## 2280 DPU HARDWARE

**WANG****ECO****ECO NO. 36643**

PART NO. 210-7422  
 DWG NO. 7422  
 MODEL NO. 2280  
 CLASS I (II) III

DESCRIPTION  
 2200 SMD ECC/Device Interface  
 PEP # PEP# H0133A  
 TYPE  HARDWARE  SOFTWARE

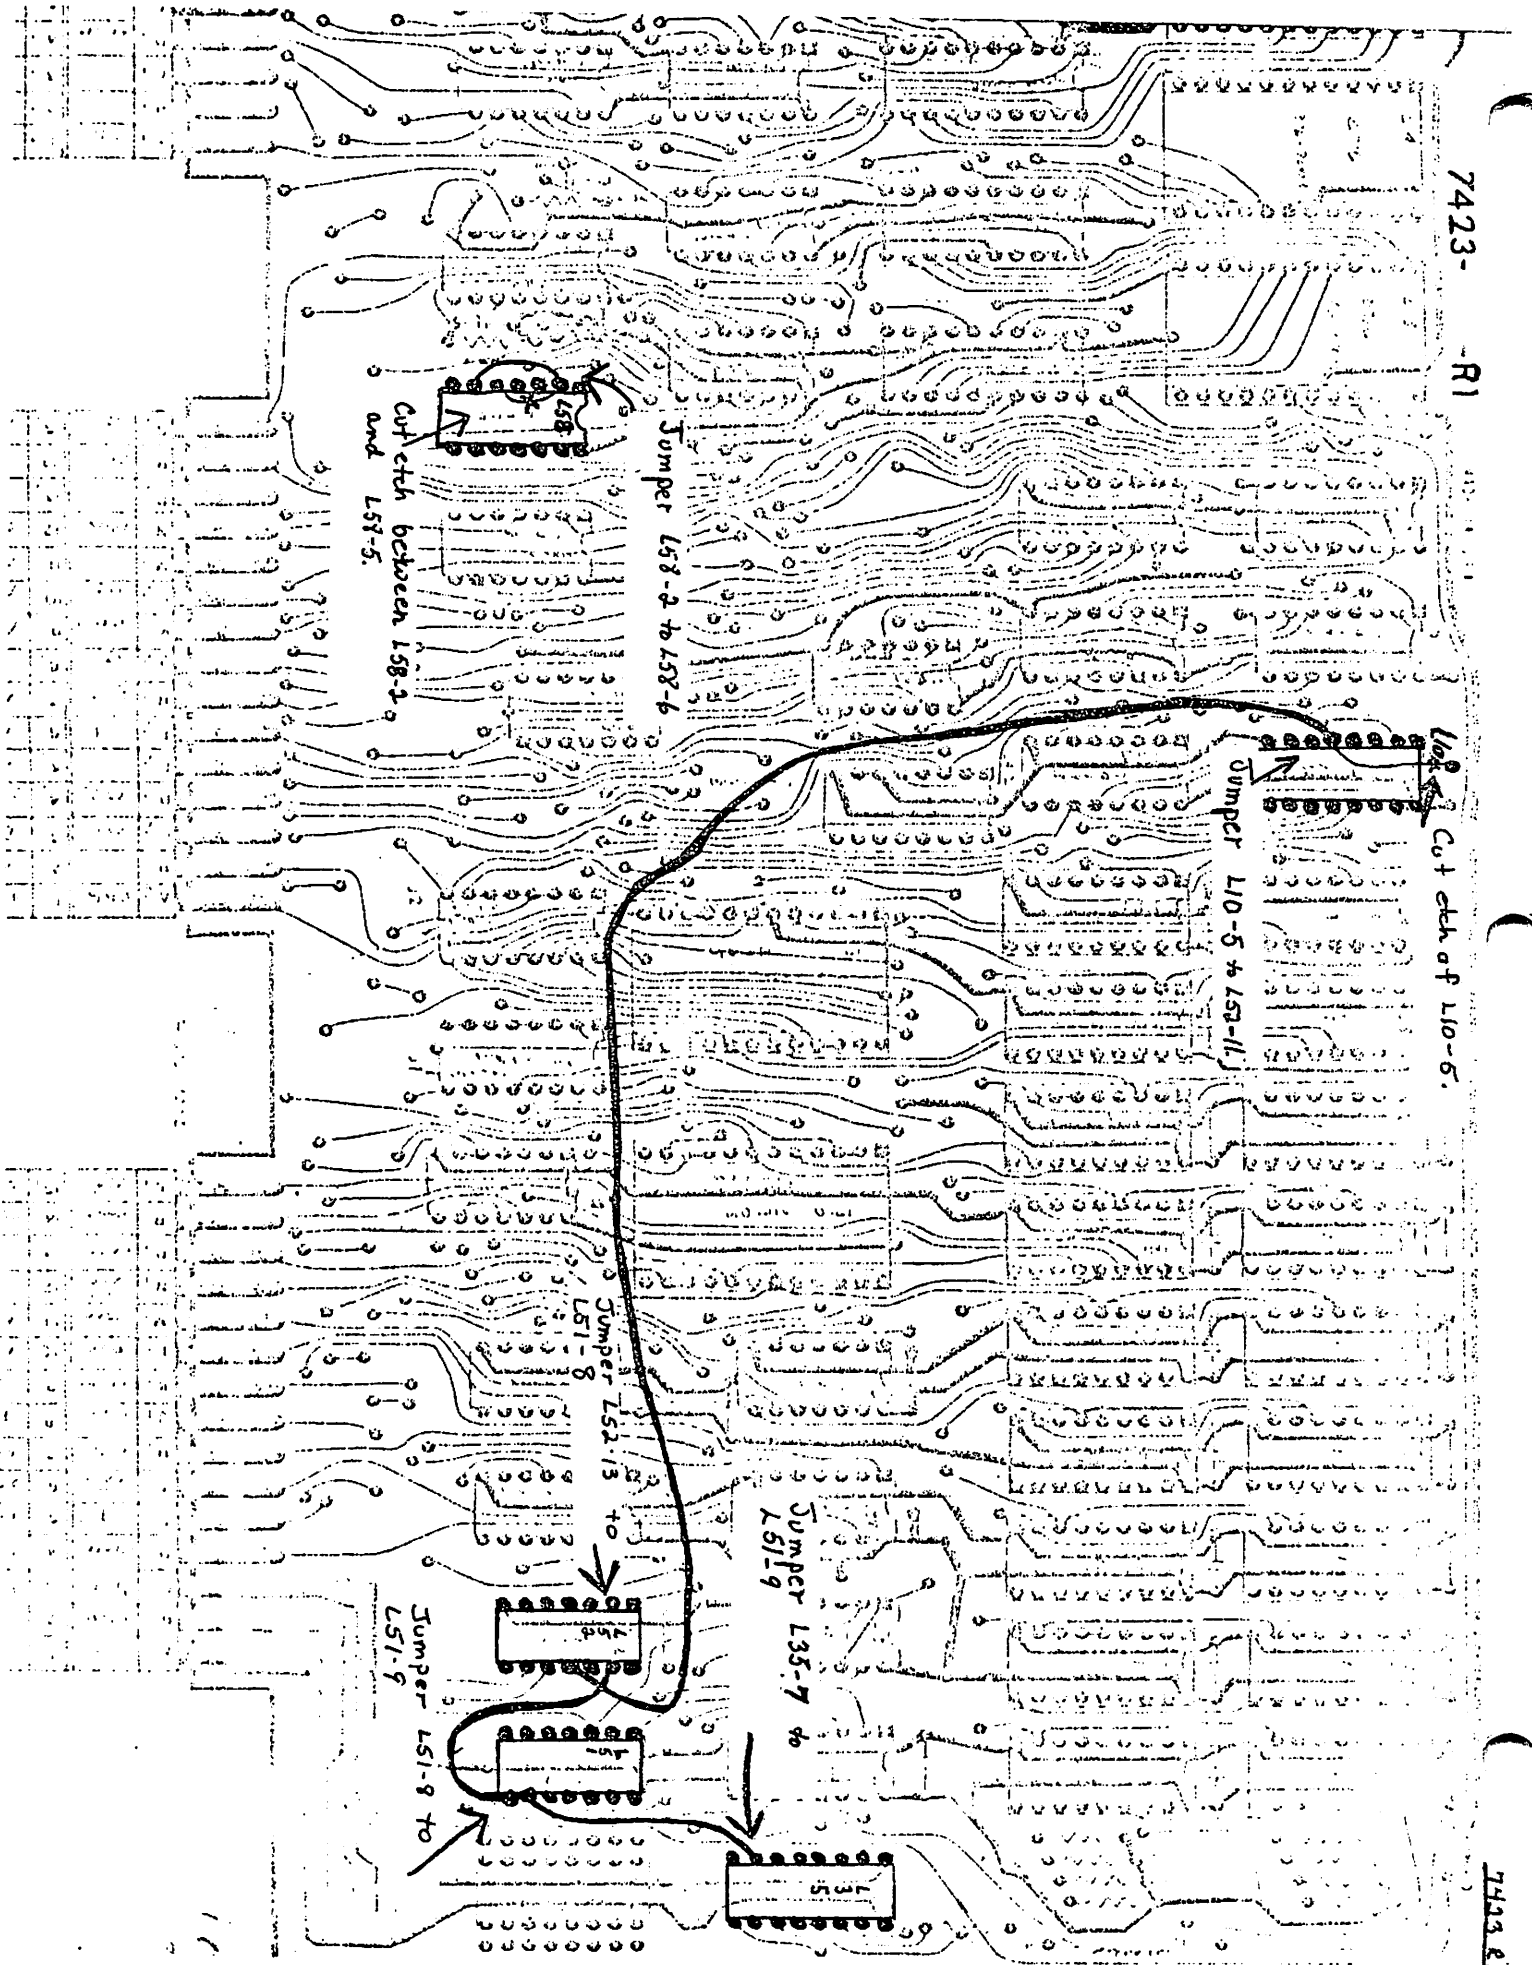
TO CORRECT FORMAT PROBLEMS AND ENSURE PROPER LOADING OF THE  
INSTRUCTION REGISTER.

1. CUT ETCH CONNECTING TO L10-5.
2. JUMPER L35-7 TO L51-8+9 AND TO L52-13.
3. JUMPER L10-5 TO L52-11.
4. REMOVE 100 PF CAP ON L10-5 (PER ECN 11586).
5. CUT ETCH BETWEEN L58-2+5.
6. JUMPER L58-2 TO L58-6.
7. JUMPER L51-8 TO L51-9.

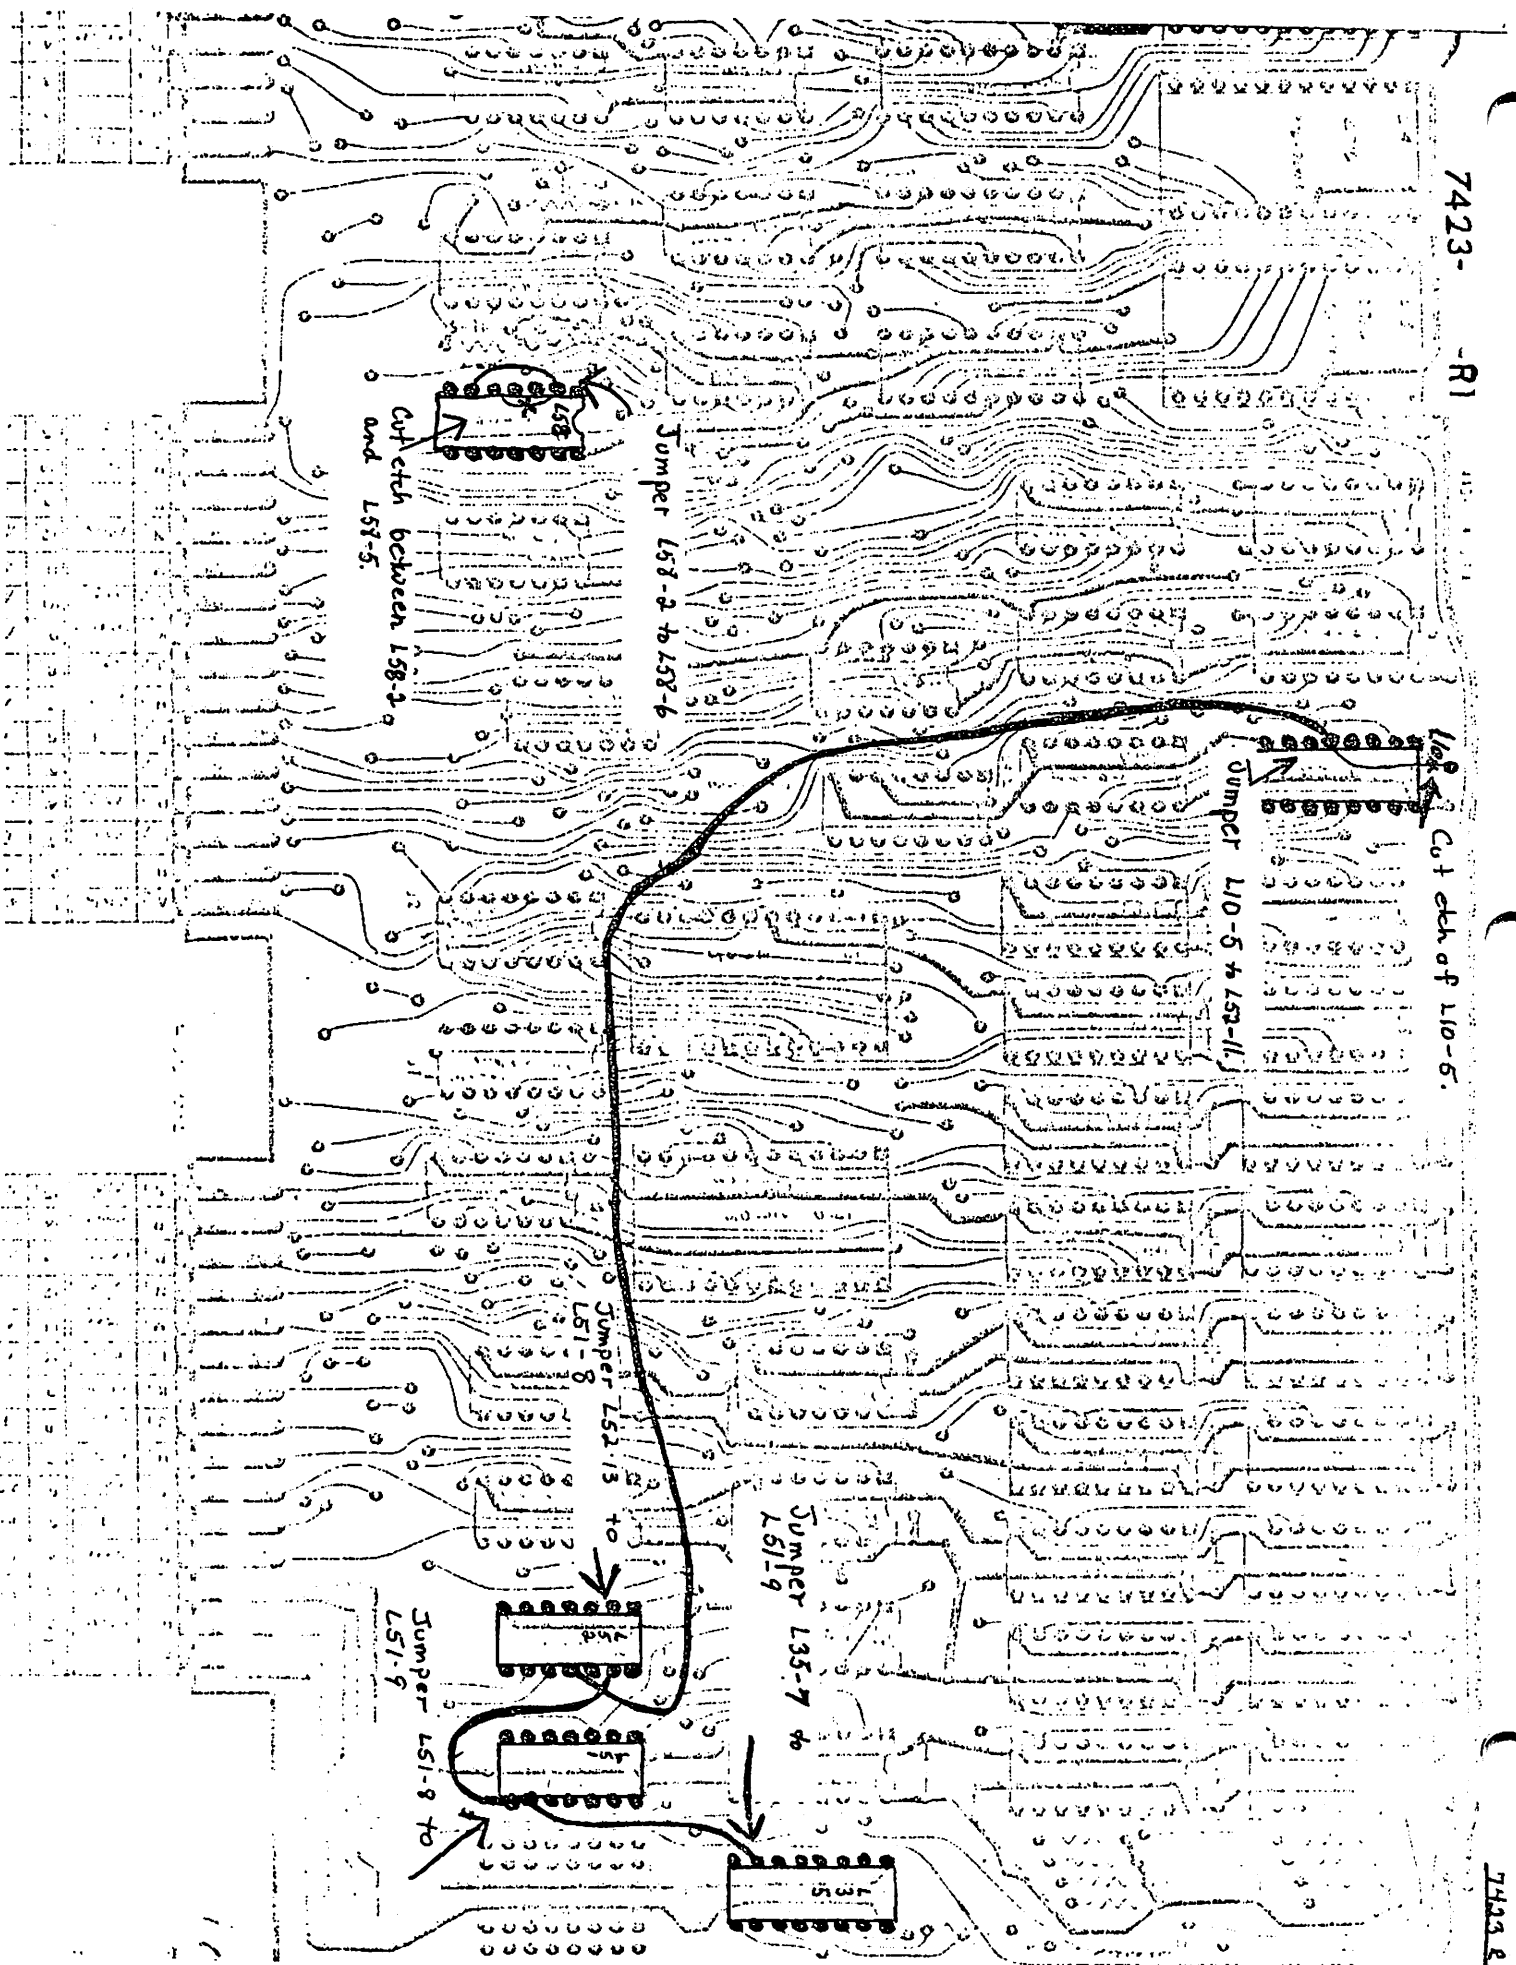
TO CORRECT FORMAT PROBLEMS AND ENSURE PROPER LOADING OF THE  
INSTRUCTION REGISTER.

1. CUT ETCH CONNECTING TO L10-5.
2. JUMPER L35-7 TO L51-8+9 AND TO L52-13.
3. JUMPER L10-5 TO L52-11.
4. REMOVE 100 PF CAP ON L10-5 (PER ECN 11586).
5. CUT ETCH BETWEEN L58-2+5.
6. JUMPER L58-2 TO L58-6.
7. JUMPER L51-8 TO L51-9.

7423  
R2

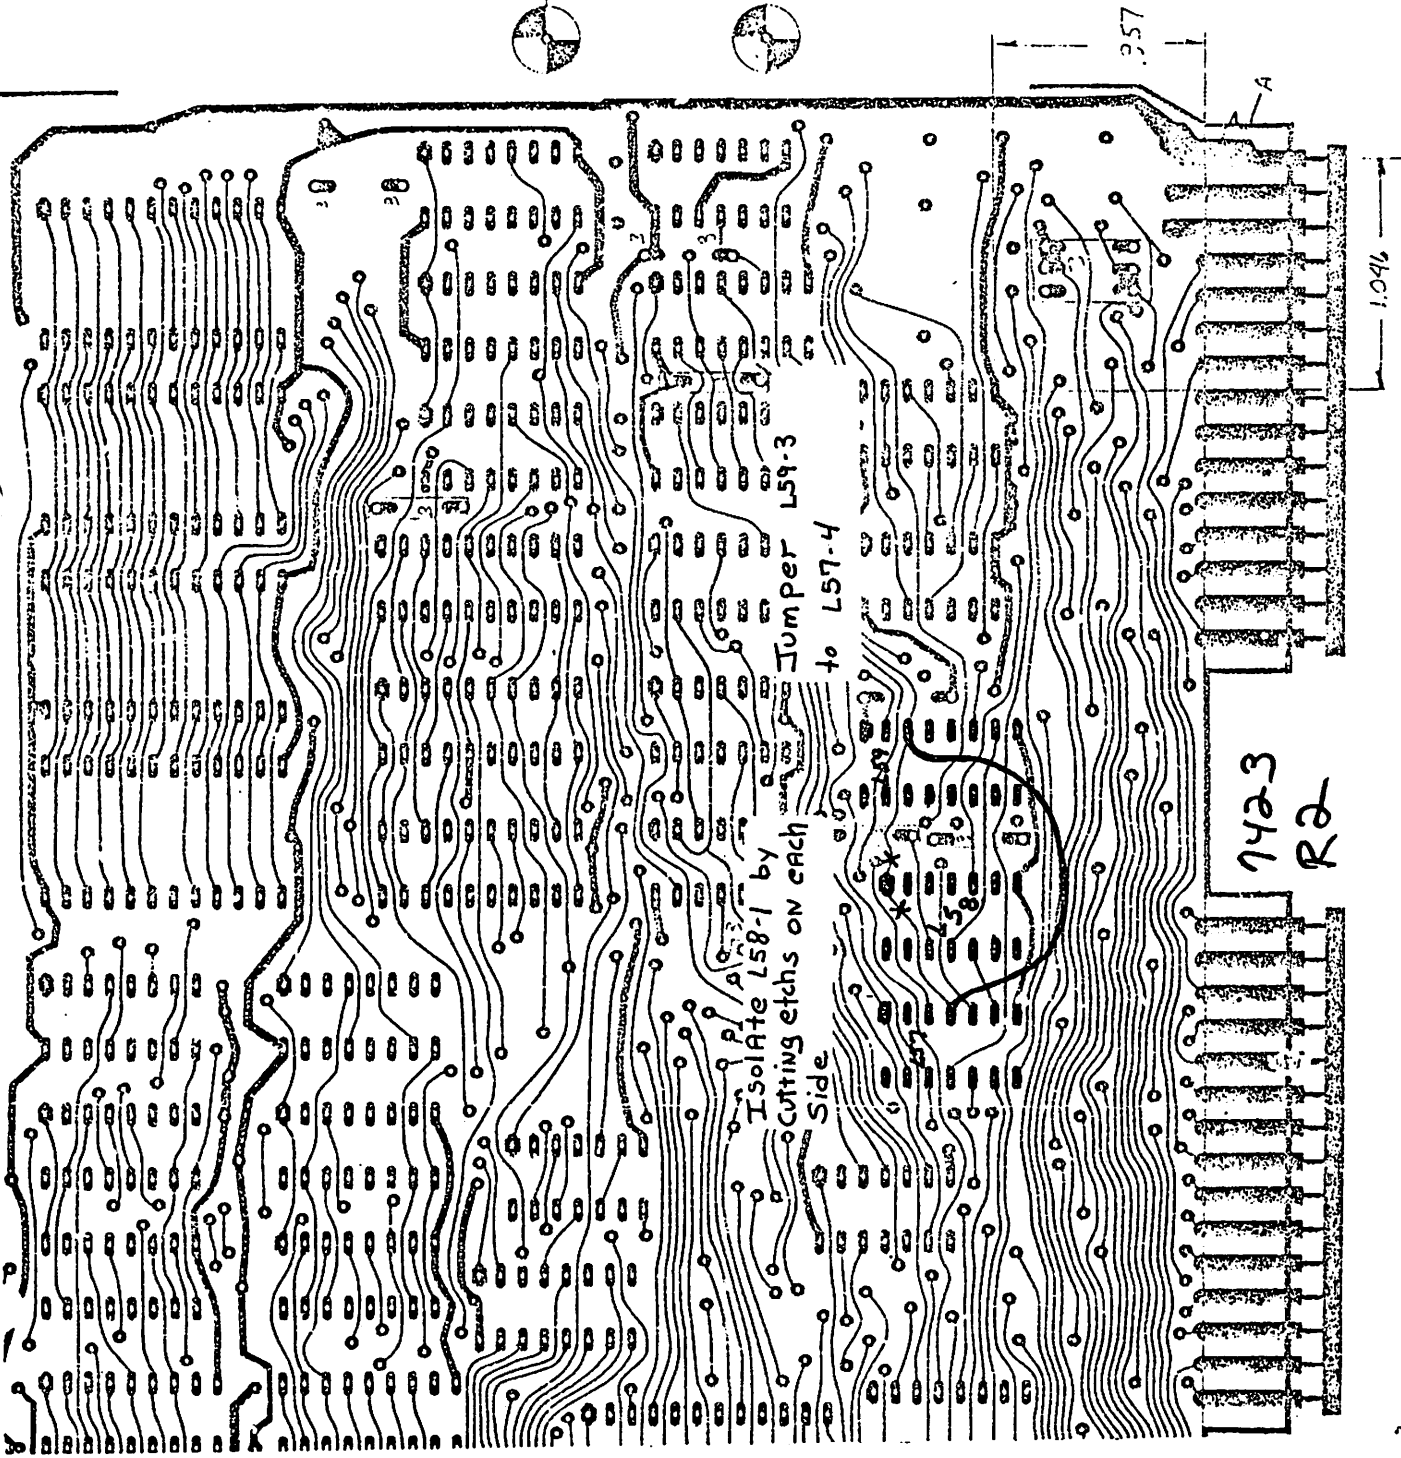
Isolate L58-1 by  
cutting etchs on each  
Side  
to L57-4

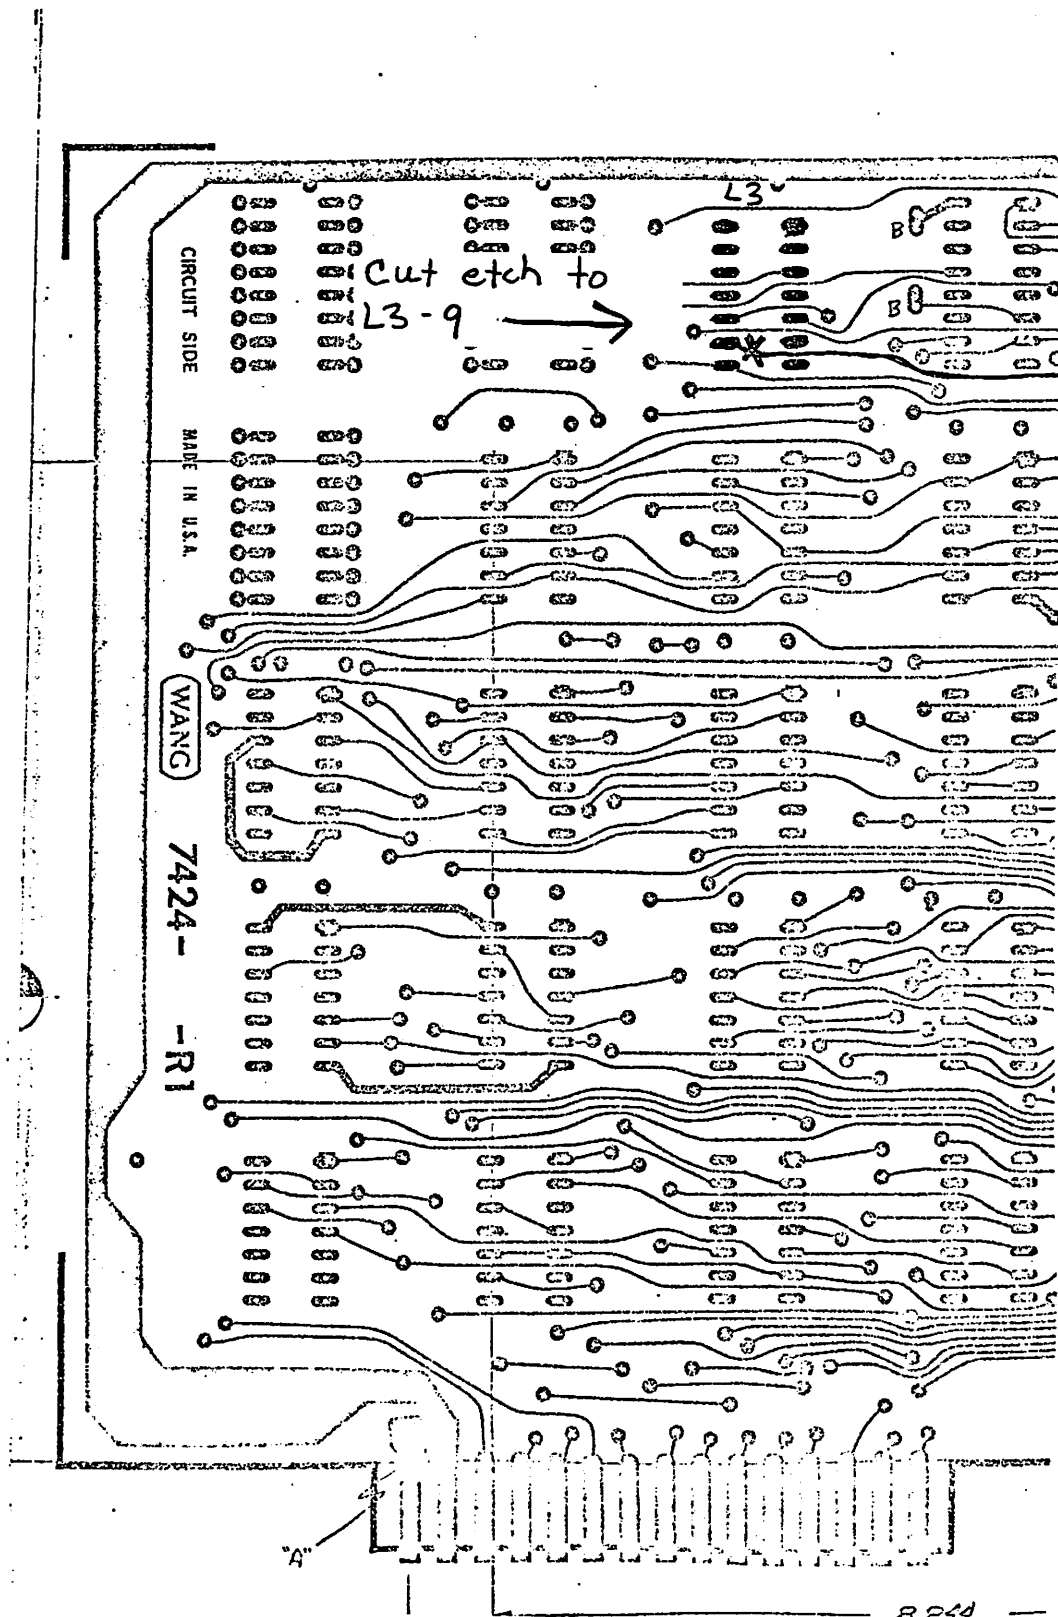
COMPONENT SIDE.

1. JUMPER L3-9 TO L3-12.
2. JUMPER L3-1,2,13 TO L6-6 AS ILLUSTRATED.

7424 - R3 ECN 12231

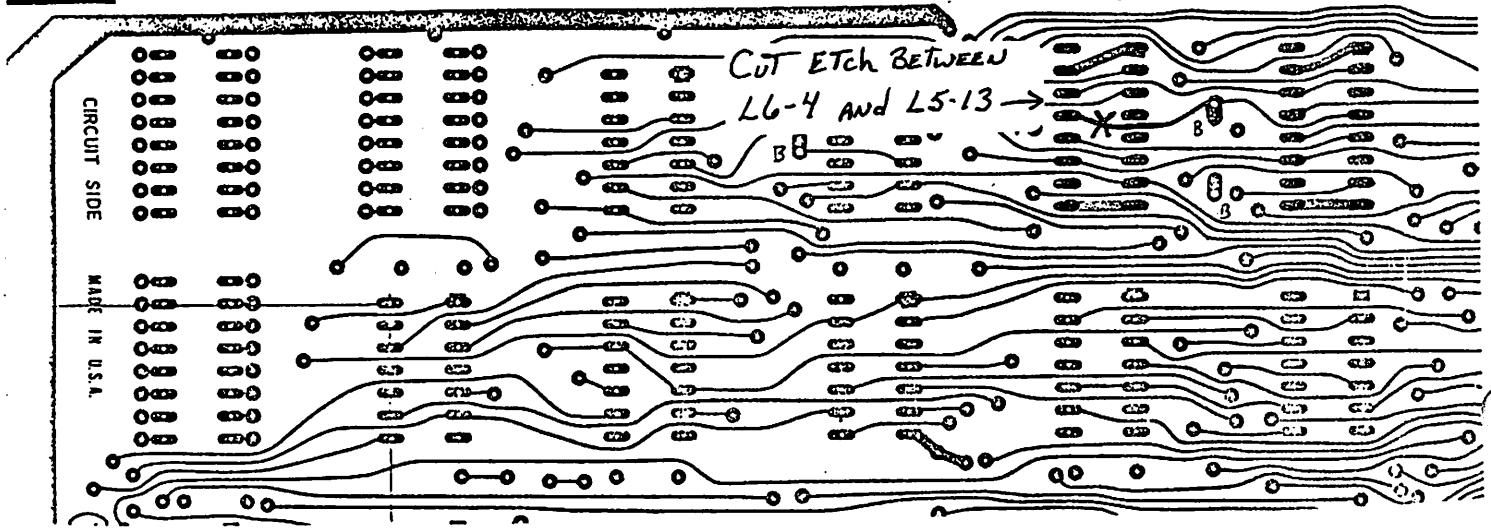
1. TO PREVENT ERRORS DURING A FORMAT OPERATION.
2. TO CORRECT ARTWORK ERRORS ON LOADING SKETCH.

1. CHANGE C1, LOCATED TO THE LEFT OF L6, FROM A 220 PF CAP TO A 470 PF CAP ( WL#300-1470 ).
2. JUMPER L6-4 TO L5-4.
